**PLANNING COMMISSION
STAFF REPORT**

May 21, 2020

AGENDA ITEM: Planning File No. 017-20-MOD: A public hearing for modifications to the approved Major Site Plan application (238-18-MAJ) for the Rainbow Court East Building mixed-use project

LOCATION: 310 East Main Street / Lots 3-5, Block 9, Frisco Townsite

North Elevation

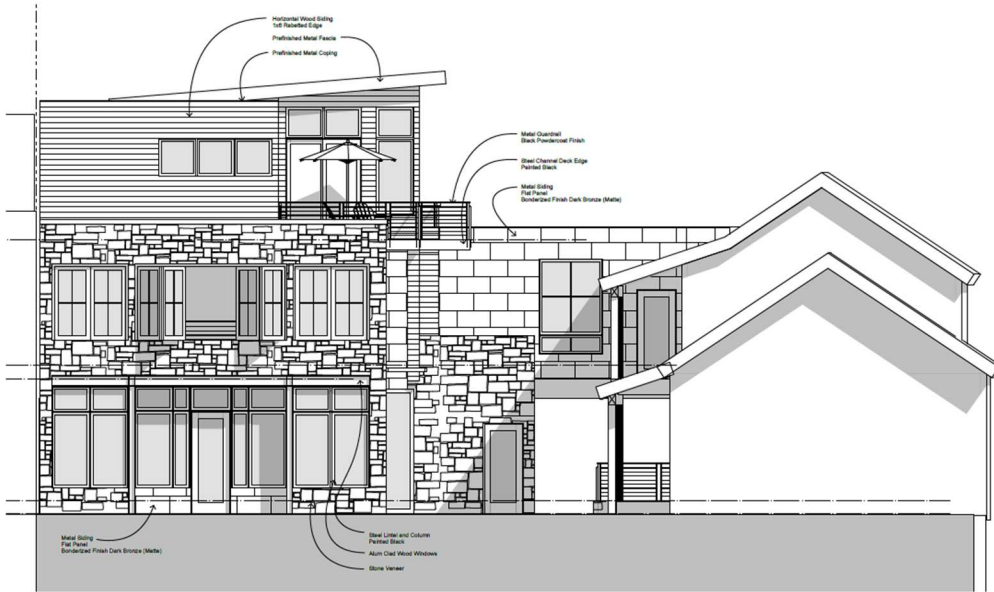
The east building is proposed to be modified from a variety of flat and pitched roofs to now having flat roofs, shallow pitched roof elements, and rooftop decks. All flat roof elements have parapets, including the roofs that face the street. The existing west building will continue to have 8:12 pitched roofs. As noted on the below image of the North and South elevations, the existing (western) portion of the building continues to have pitched roofs and the application materials depict sloped façade elements facing the street sides. The application meets this standard.

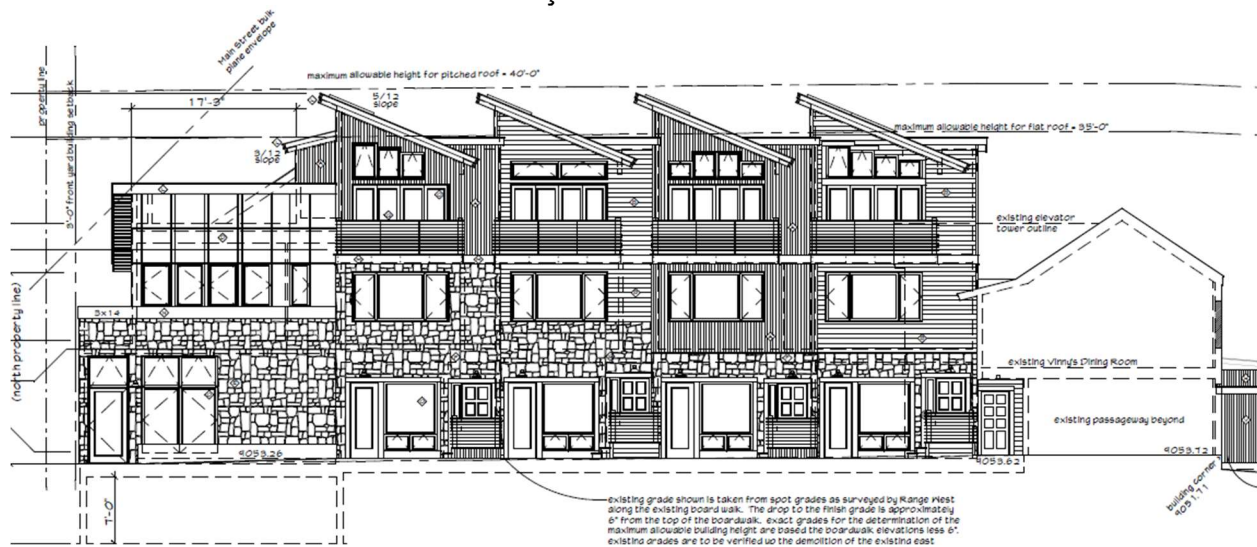
The proposed building colors include dark bronze and natural wood colors. The proposed modifications continue to meet this standard.
